AGENDA
CITY OF GLENWOOD SPRINGS
Planning and Zoning Commission
Regular Meeting
MAY 25, 2021
Council Chambers, First Floor
101 W. 8TH STREET
6:00 PM

MINUTES
City of Glenwood Springs
Planning and Zoning Commission
Regular Meeting
August 13, 2020
Zoom
6:00PM

FIGURE 8

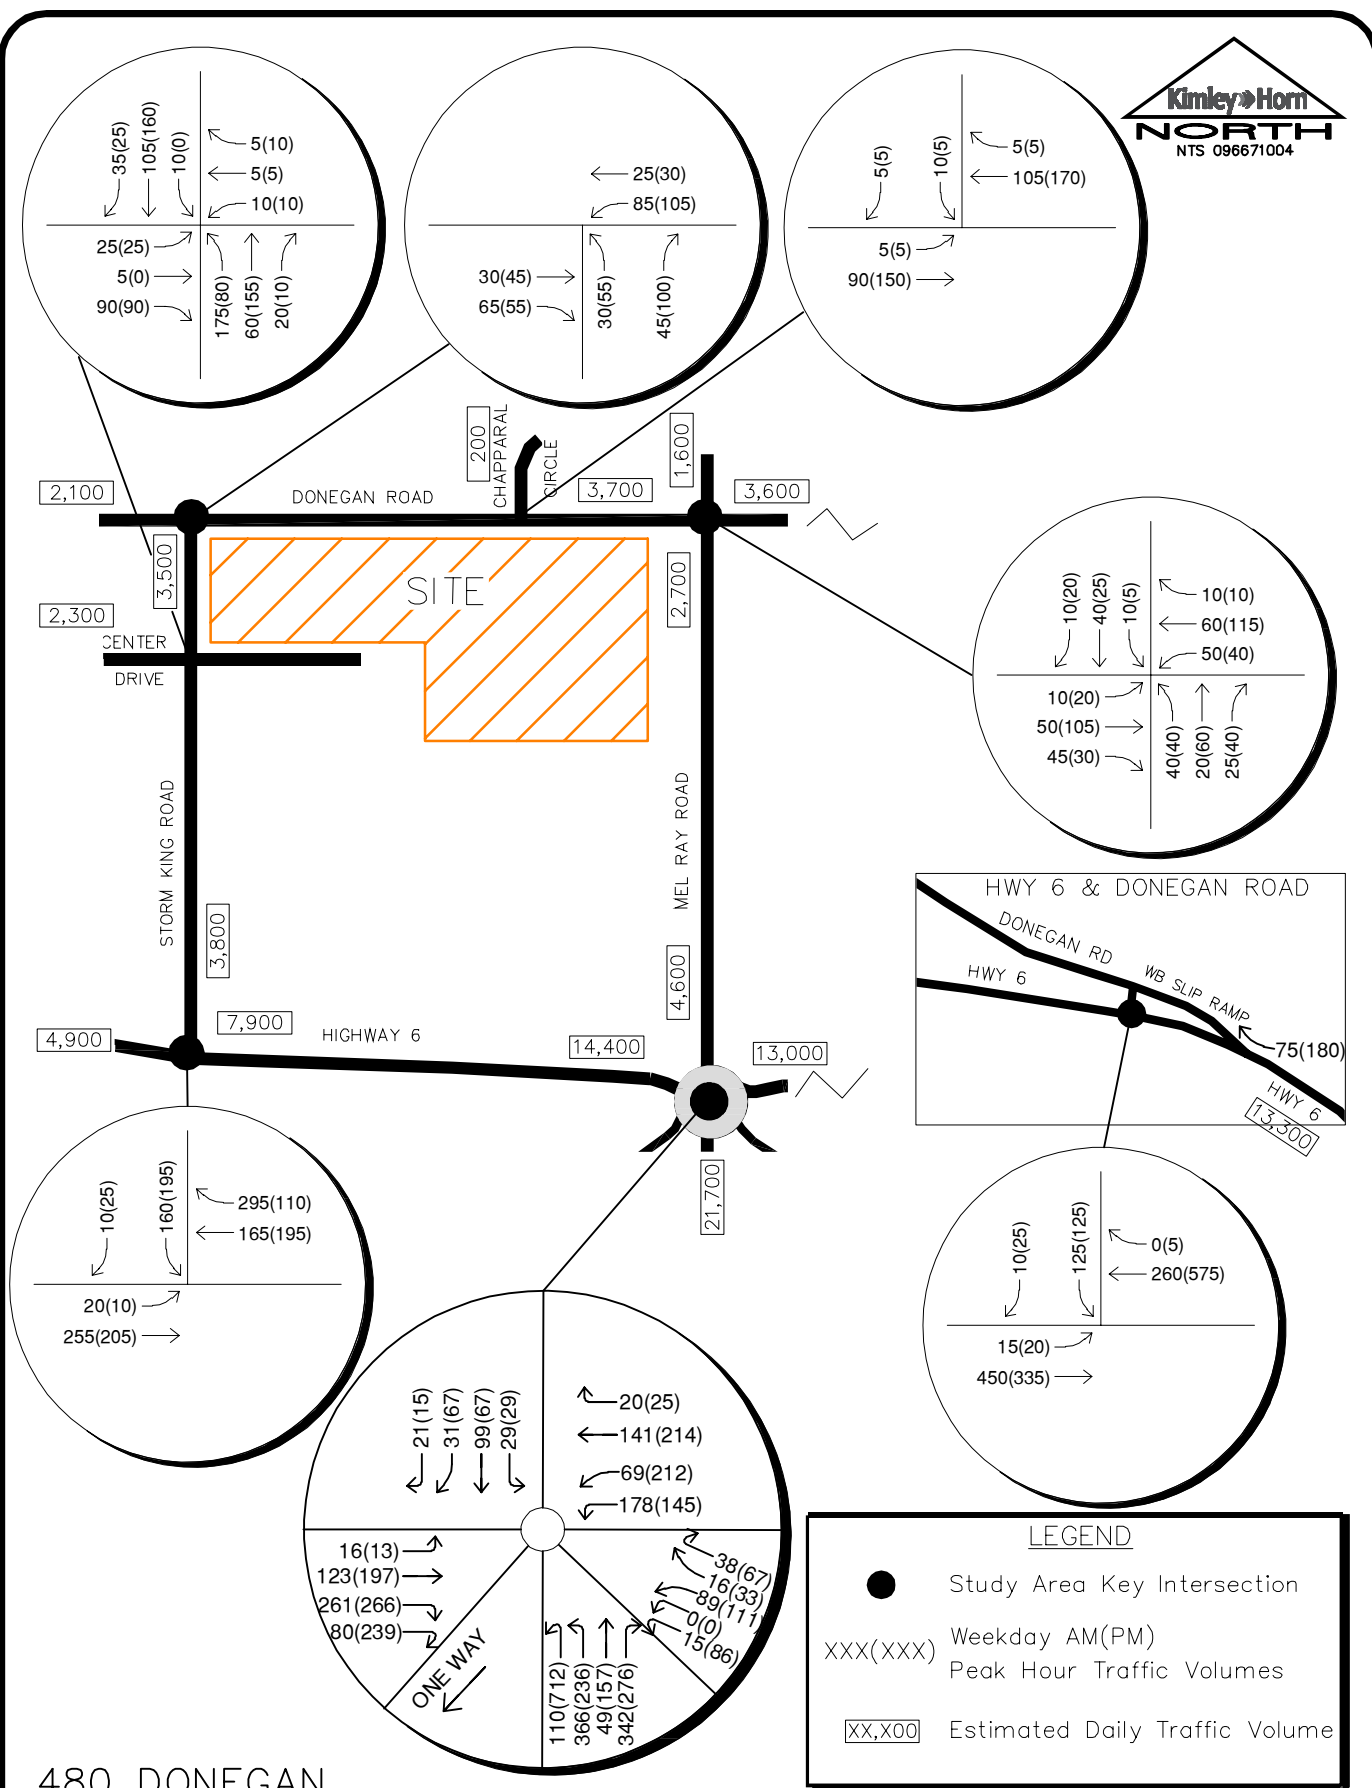
a new Mobile Home Park past Ami's Acres. Figure 7 is inconsistent with the surrounding growth. How come Hwy 6 from Storm King Rd to Mel Rey Road DECREASES from the 2020 Existing Adjusted Volumes – Figure 5 (9500 DTV) to the 2040 Background Traffic Volumes – Figure 7 (8300 DTV) while surrounding roadways/intersections increase? The figures are inconsistent:

Figure 4 (Existing Volumes): HWY 6 DTV = 6,600

Figure 5 (2020 Existing Adjusted Volumes): HWY 6 DTV = 9,500

Figure 6 (2022 Background Traffic Volumes): HWY 6 DTV = 7,700 (**Lower than the 2020 adjusted volumes**)

Figure 7 (2040 Background Traffic Volumes): HWY 6 DTV = 8,300 (**Lower than the 2020 adjusted volumes**)

DATE	REVISION
TITLE PRELIMINARY GRADING PLAN	
DRAWING NO. C-3.0

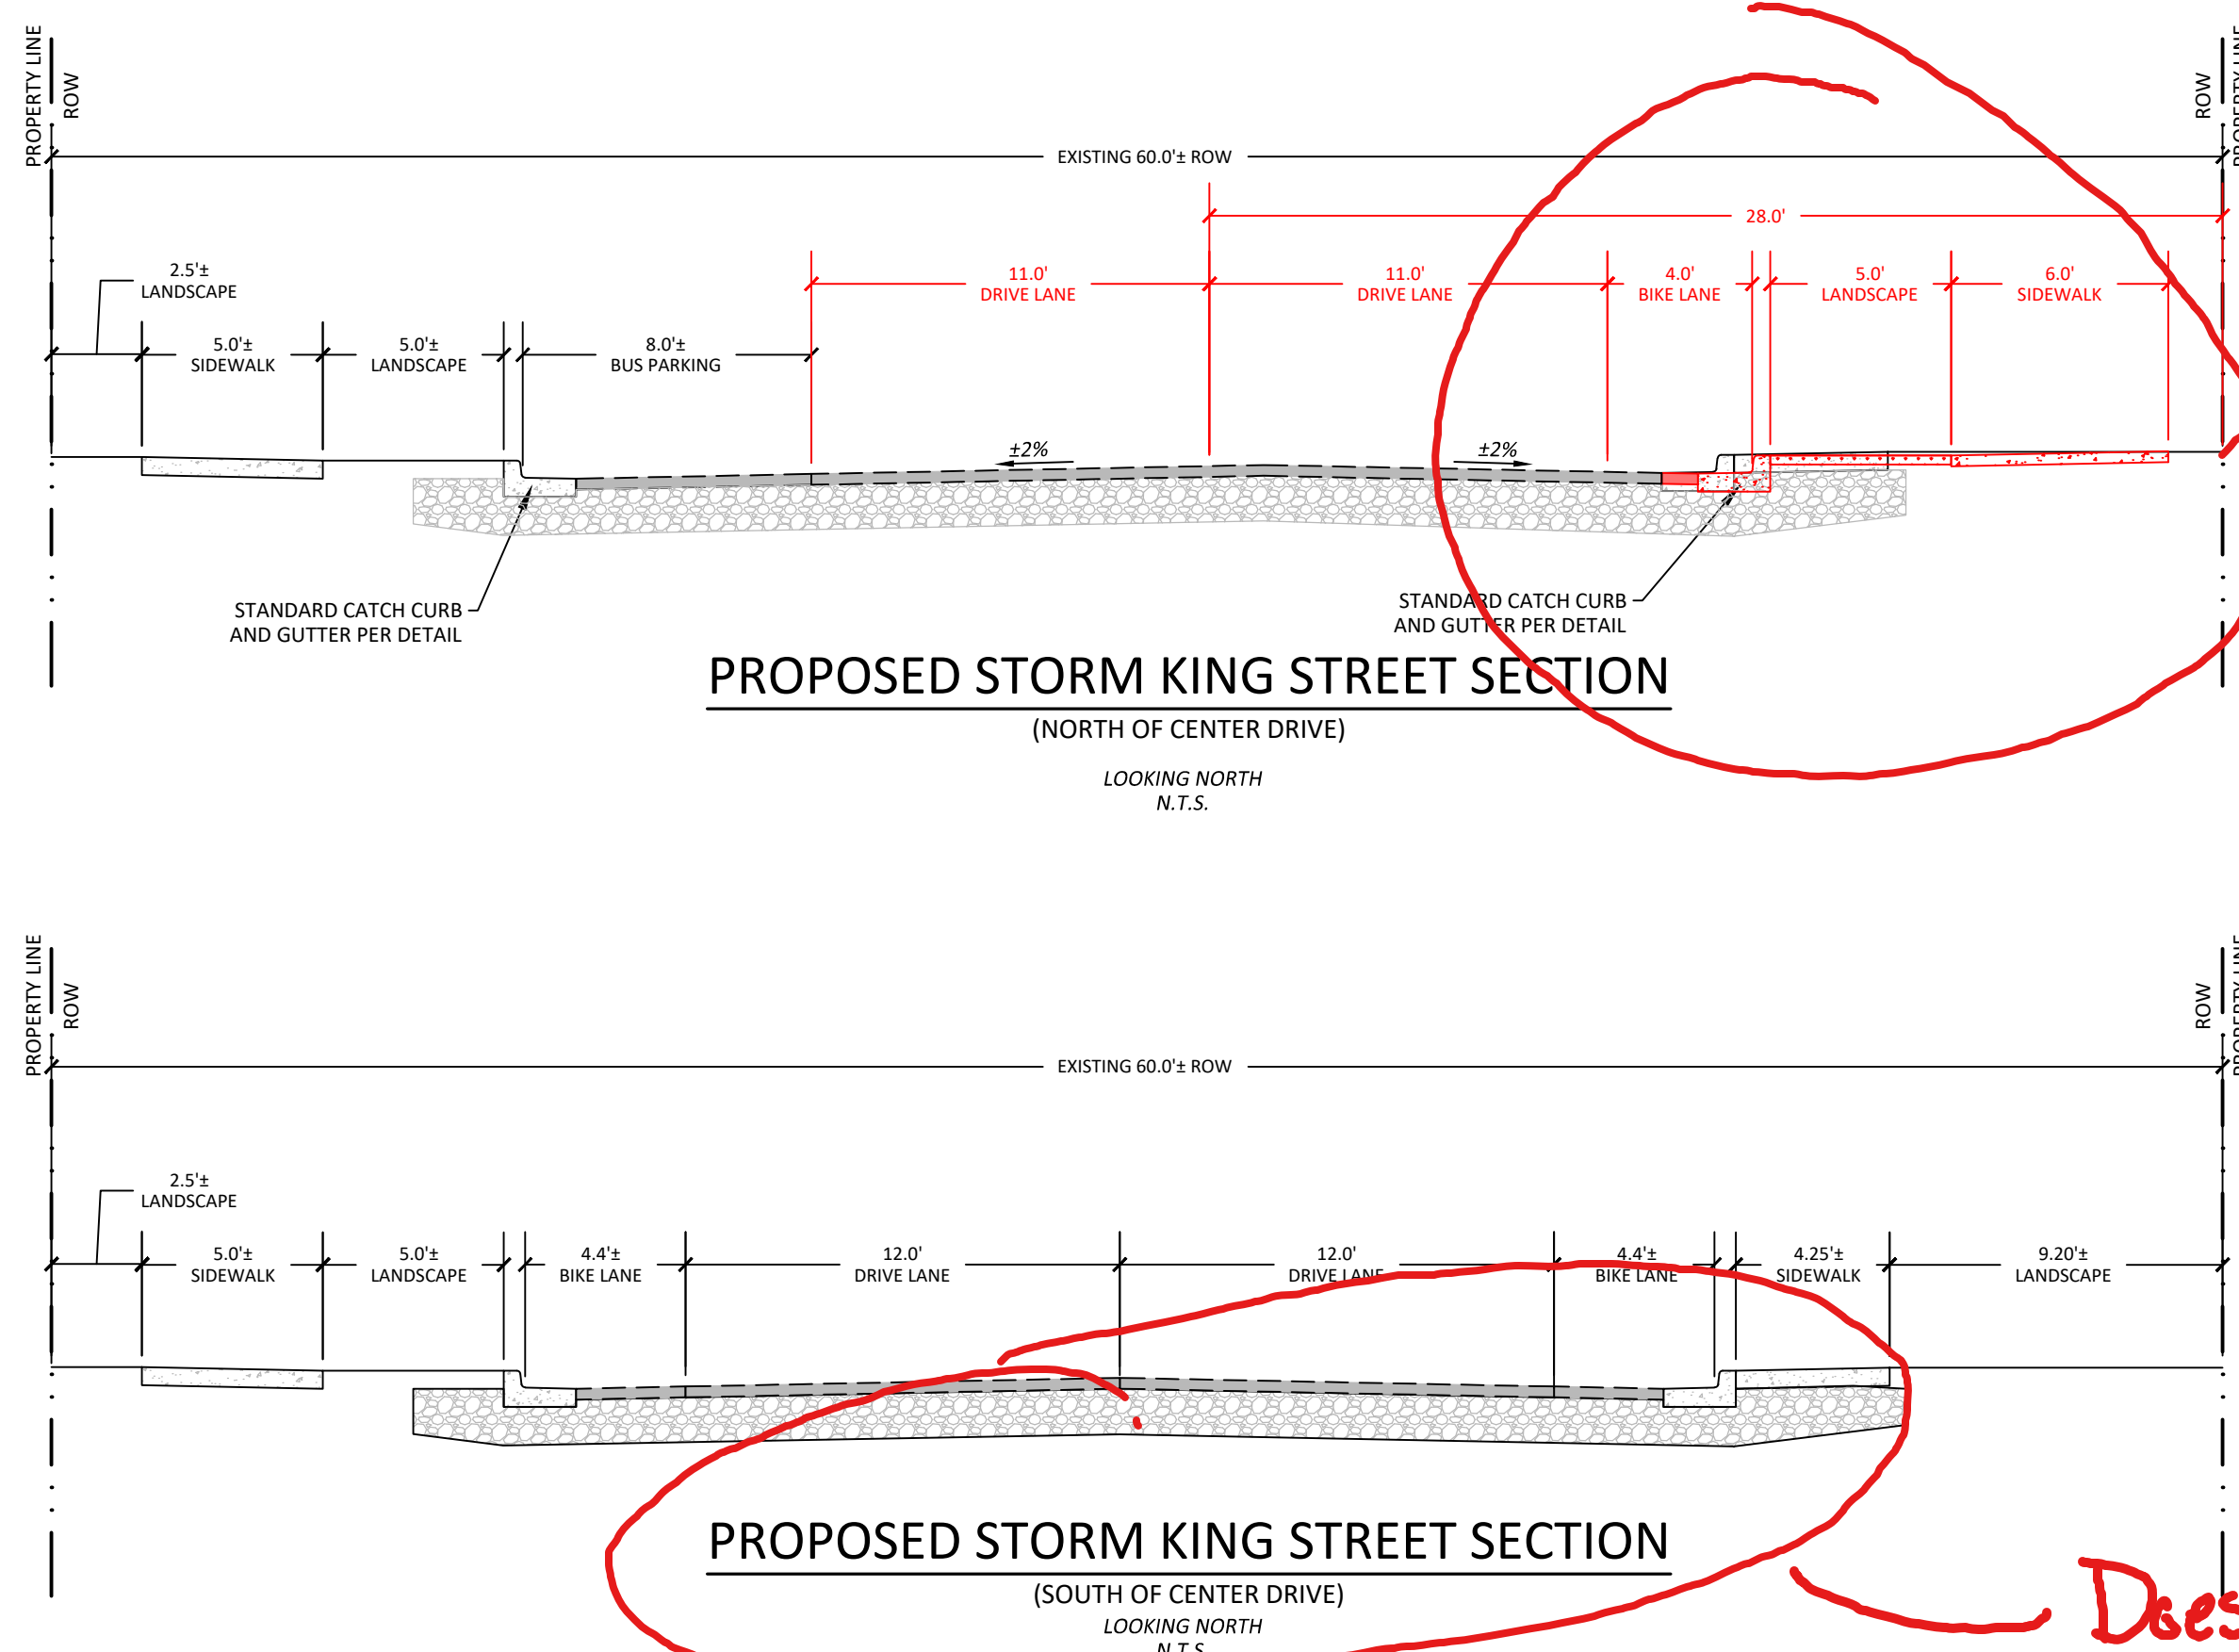
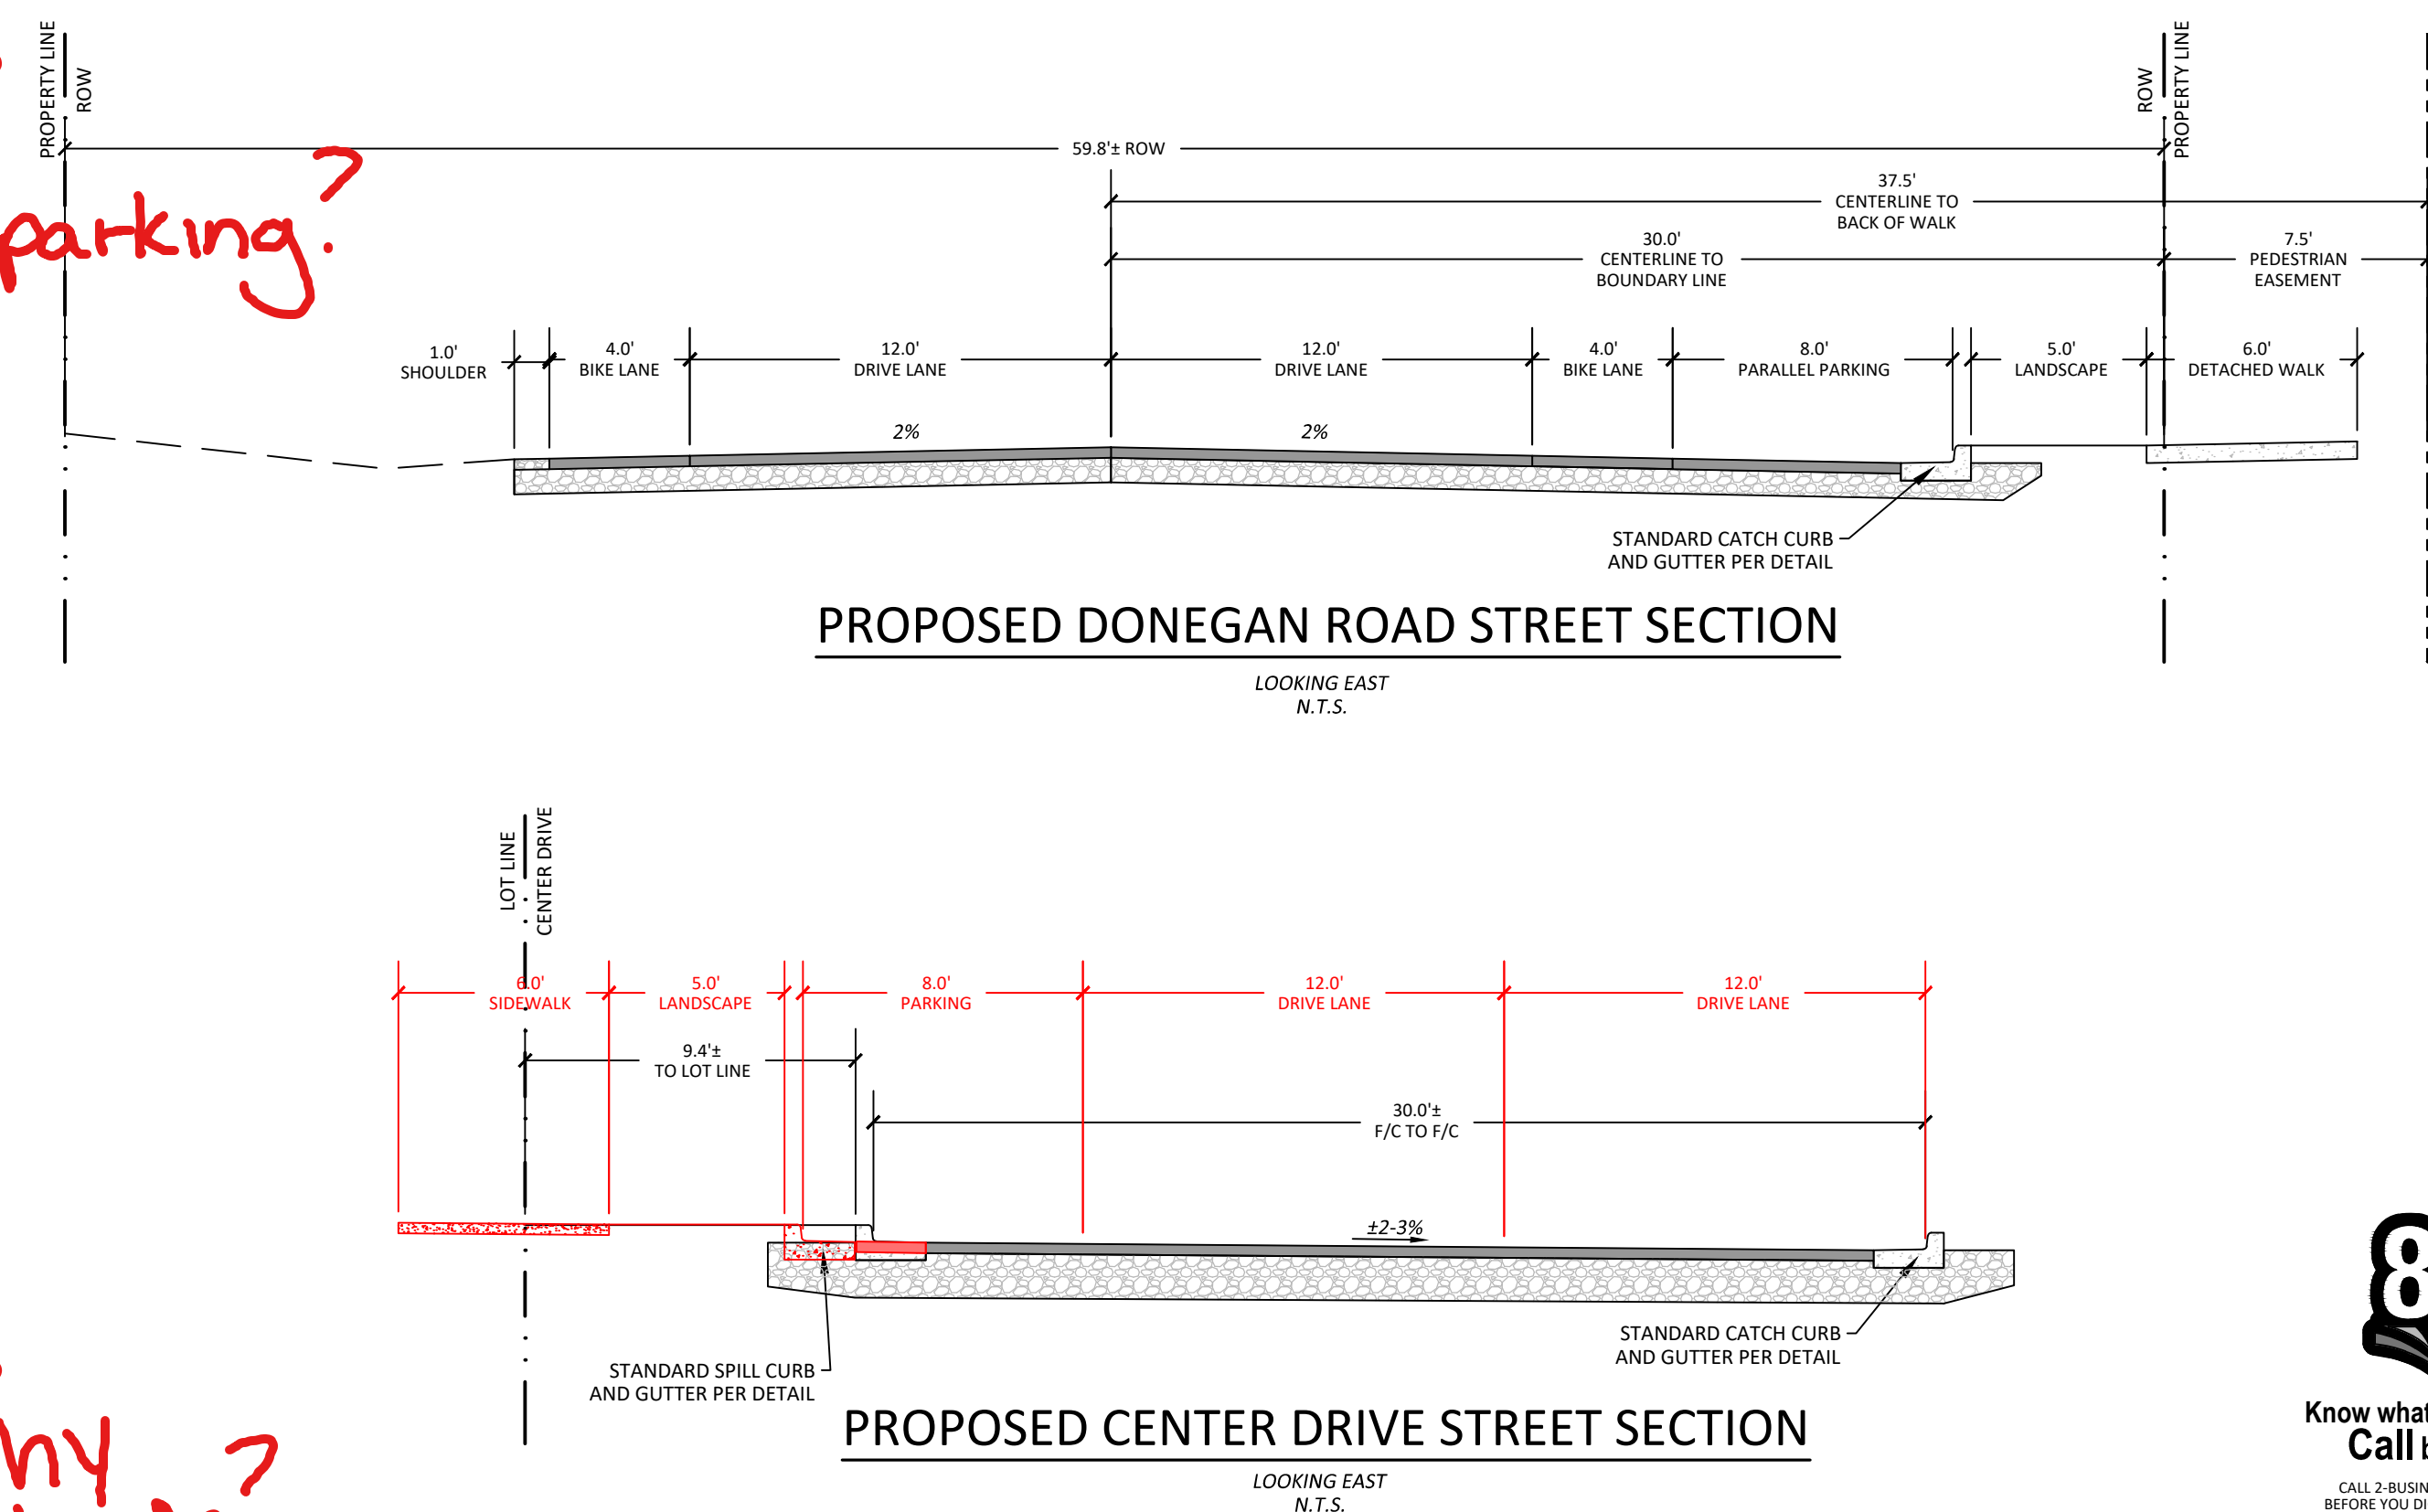
- Doesn't appear to be changing - why shown?
